Proposal for Condition of Activation of DPPS

9th IWG-DPPS

January 2021

BASt/BGS Proposal for Condition of Activation of DPPS

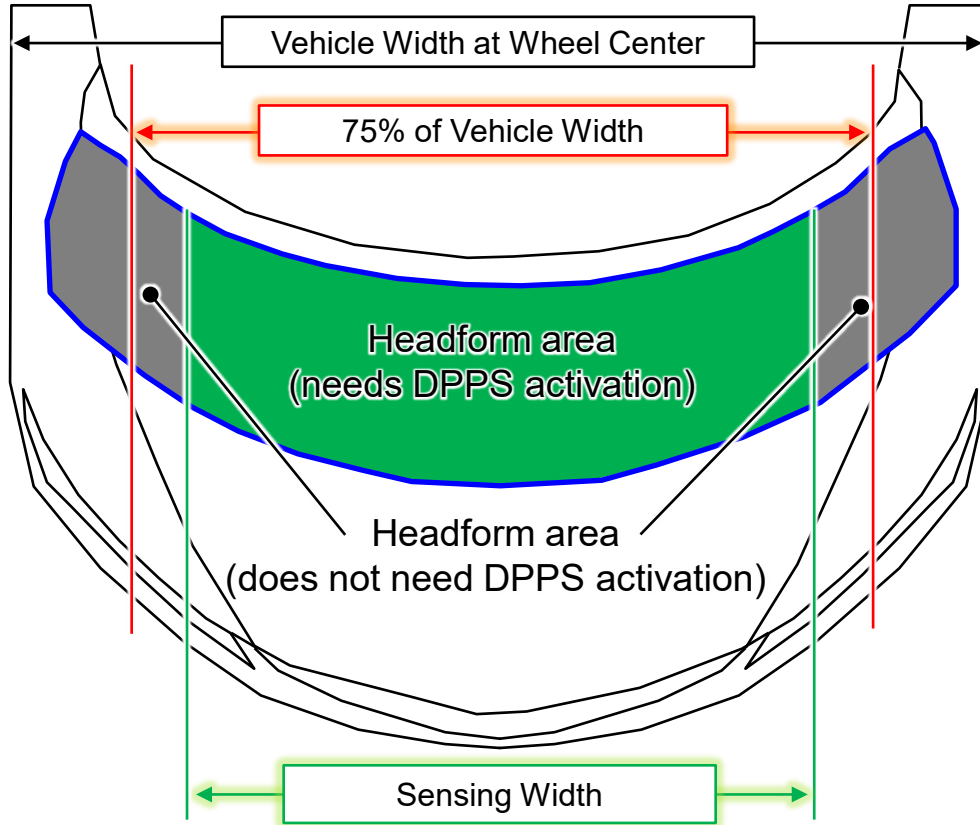
Issue with BAsT/BGS Proposal for Sensing Width

BAsT/BGS proposal does not allow headform test with DPPS being activated for the system whose sensing width is narrower than 75% of vehicle width, even if OEM shows the sensing performance in the area relevant to headform test area where DPPS activation is needed

Headform tests should be conducted with DPPS being activated in the headform test area where the detection performance is clarified

DPPS can be activated in whole of headform test area on the bonnet in case the sensing width is wider than the width defined by the outer most of following three definition;

- 1) Outer most of bumper test area
- 2) Vehicle width at front wheel center minus 12.5% of the width
- 3) Vehicle width at front wheel center minus 250mm

In case the sensing width is narrower than aforementioned width, DPPS can only be activated within the sensing width.
